TO: Parks and Recreation Board

DATE: May 28, 1991

**TO:** Parks and Recreation Board  
**FROM:** Manuel A. Mollinedo, Director  
Parks and Recreation Department  
**DATE:** May 16, 1991  
**SUBJECT:** Town Lake Park, Request for Easements  
South Austin Relief Main, Phase 1

SUBJECT: Request for Easements Across Parkland  
South Austin Outfall Relief Main, Phase I  
CIP No. 436 237 0395

FOR BLAKE ROBINSON

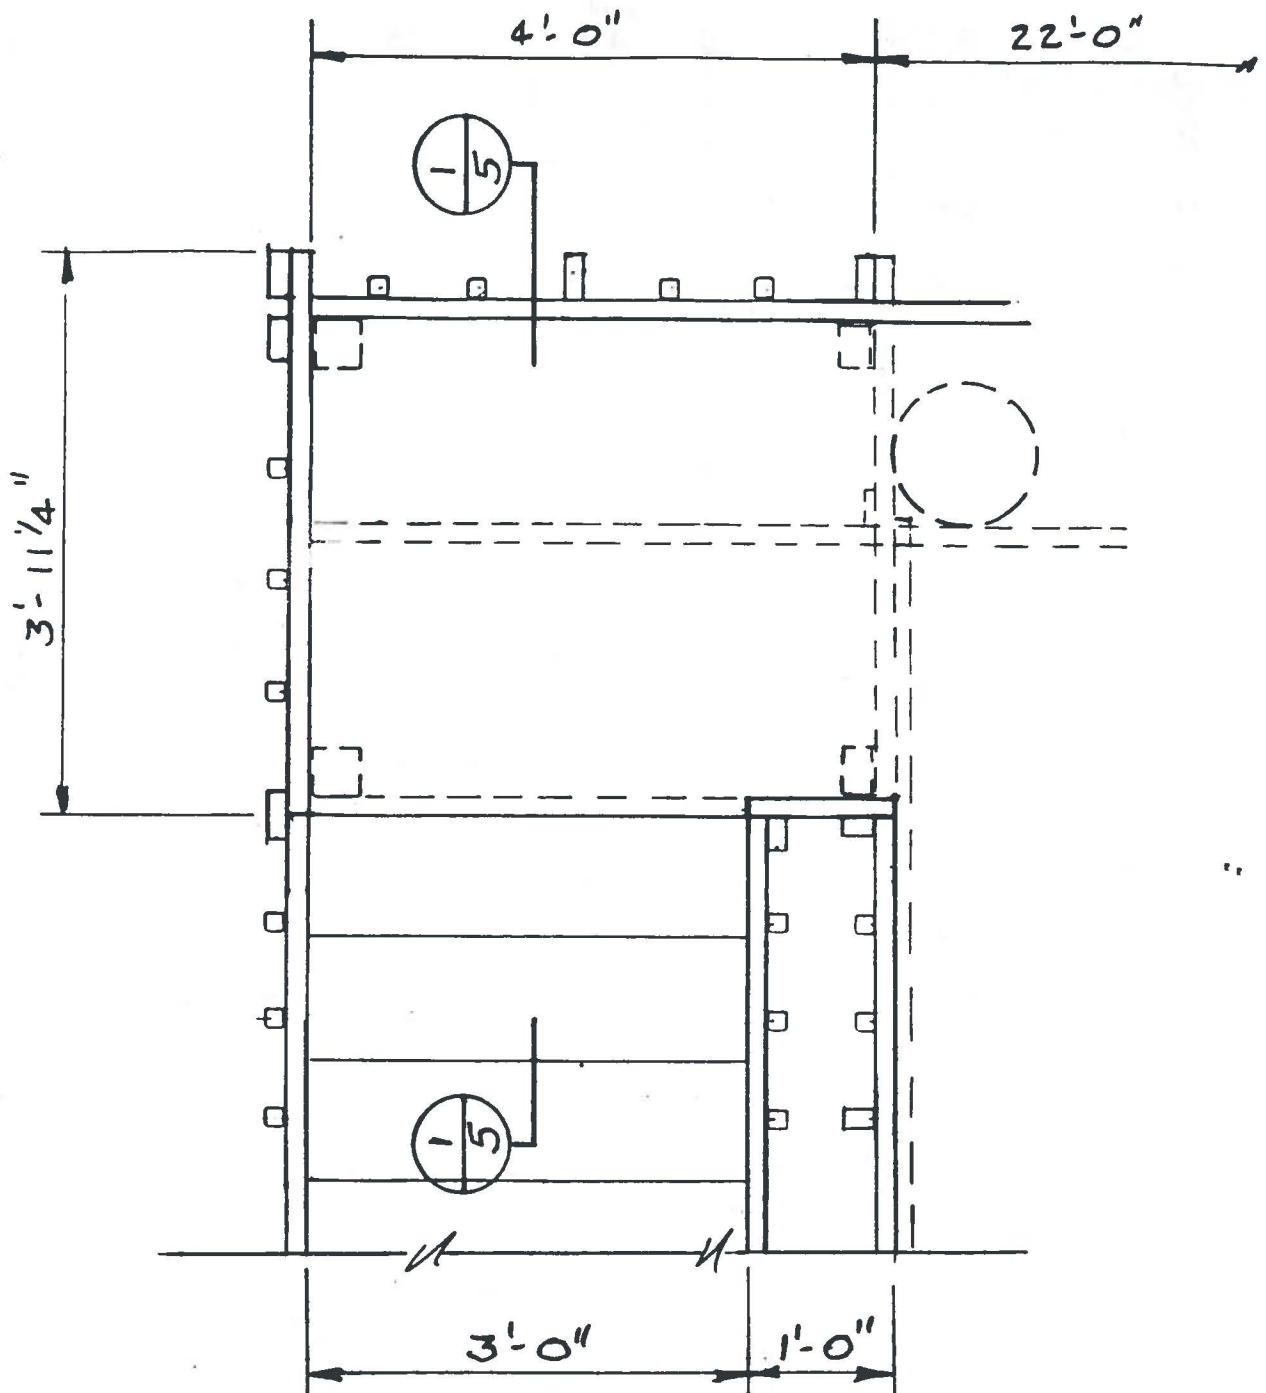
The plans for the boat dock specify Creosote treated timber for the pilings in the water; only CCA treated or natural decay resistant timber, or inert materials are permitted as pilings in the water. It is not known whether the creosote pilings have been installed.

PD 1. The boat dock plans specify Creosote treated timber, only CCA treated timber, natural decay resistant timber or inert materials are permitted as pilings in the water.

PD 6. The letter of request addressed to the Parks and Recreation Board refers to construction at 12425 riverbend, Lot 6 Freund Sleepy Hollow, with construction scheduled to commence December 1, 1984. Is this correct? If not a new letter of request for the Board to consider 12605 Riverbend is required.
